ADDENDUM No. 2 TO THE CONTRACT DOCUMENTS JUNE 17, 2024 PROJECT NO. 9557220 SESP 1P746 RAD RECONFIGURE SPACE FOR NEW CT SCANNERS

ITEM NO. I – CLARIFICATIONS

SKETCH #1

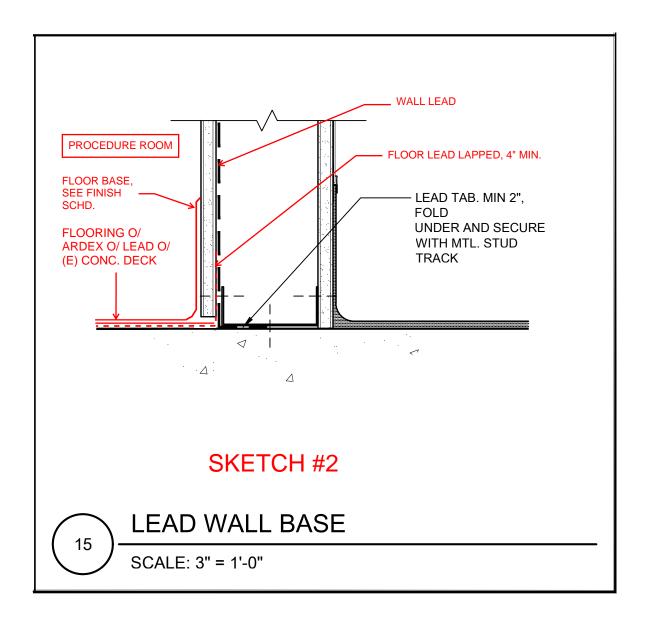
Q3: Per 1D/A-412 temp. construction barrier is not shown or called out around the existing 1P746 demo space.

- a. Please clarify if the construction barrier that will need to be type T or T1.
- b. Please show construction barrier and clarify clearances required between construction barrier and adjacent existing CT room 1P742.

A3:

- a. Type T, see attached Sketch #1.
- b. See attached Sketch #1.

SKETCH #3

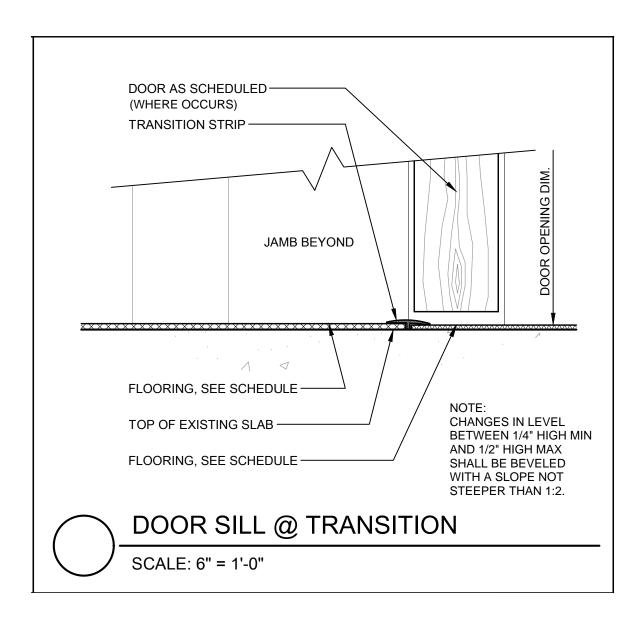
Q1: Per renovation Keynotes #11 "Prep conc. Slab and apply 1 lb. lead sheeting seal & level as req'd." No further scope is shown on the plans or the extent of where the lead sheeting is to be placed. Per sheet A630, flooring type SR1, 2 & 3 is to be installed with a wave pattern in room 1P746 however specifications and details do not call out lead sheeting or installation method.

- a. Is lead sheeting to be placed on the entire floor or just under the CT scanner?
- b. If lead sheeting is to be installed over the entire floor, please provide details for transitions at door and walkways.
- c. If lead sheeting is to be installed under CT Scanner please provide further details for transition locations.
- d. If lead sheeting is to be installed over the entire floor, please provide revised cove detail.
- e. Please update spec to include the lead sheeting in flooring spec.

- a. Lead sheeting to cover the entire room 1P746.
- b. See attached Sketch #3.
- c. Lead sheeting to cover the entire room 1P746.
- d. See attached Sketch #2.
